Access Compliance Report

Public Rights-of-Way

Intersection ID: 44909	Main Street: PALUSTRIS_CT	Cross Street: OAKBURN_DR	Location: NW
ADA ID: 5A143FCD7EA4	Ramp Type: PerpDiag	Initial Pass/Fail: Fail	Overall Compliance: No
Severity Score: 8.75			
Codes/Mitigation Info/Possible Solution		Field Measurements/Component Compliance

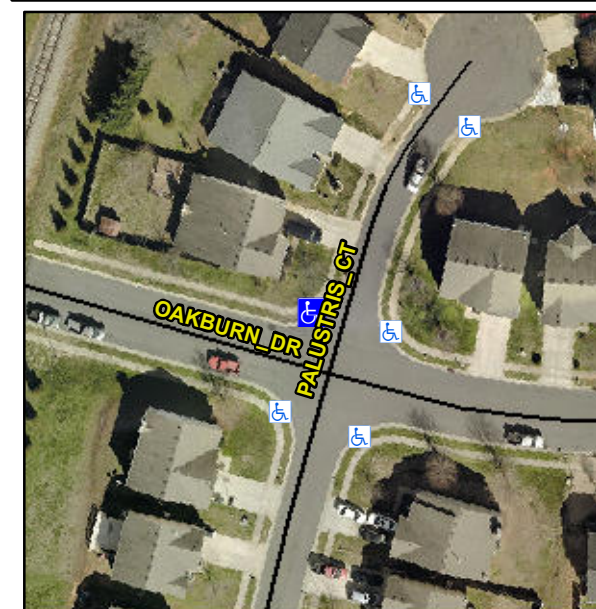
Not Found, R304.5.1

Compliance	Description	Data	Compliance	Description	Data
N/A	Ramp Length (in)	46.5	Yes	Ramp Slope (%)	8.3
No	Ramp Width (in)	43.0	Yes	Ramp XSlope (%)	1.9
N/A	Flare Type LT	N/A	N/A	Flare Type RT	N/A
N/A	Flare Slope LT (%)	N/A	N/A	Flare Slope RT (%)	N/A
N/A	Flare Traversable LT?	N/A	N/A	Flare Traversable RT?	N/A
N/A	Landing Length (in)	N/A	N/A	DWS Provided?	N/A
N/A	Landing Width (in)	N/A	N/A	DWS Contrast?	N/A
N/A	Landing Slope (%)	N/A	N/A	DWS Length (in)	N/A
N/A	Landing X Slope (%)	N/A	N/A	DWS Full Width?	N/A
N/A	Landing Curb? (Y/N)	N/A	N/A	DWS Offset (in)	N/A
N/A	Shared Landing?	N/A			
N/A	Gutter Ponding?	N/A	N/A	Gutter Slope (%)	N/A
N/A	Gutter Lip Ht (in)	N/A	N/A	Gutter X Slope (%)	N/A
N/A	Painted X Walk1?	No	N/A	Painted X Walk2?	No
	X Walk 1 Direction	To SW		X Walk 2 Direction	To SE
N/A	X Walk 1 Width (in)	N/A	N/A	X Walk 2 Width (in)	N/A
	X Walk 1 Slope (%)	0.1		X Walk 2 Slope (%)	1.4
	X Walk 1 X Slope (%)	2.1		X Walk 2 X Slope (%)	0.8

Remove & Replace Curb Ramp With Two New Directional Ramps or Equivalent.
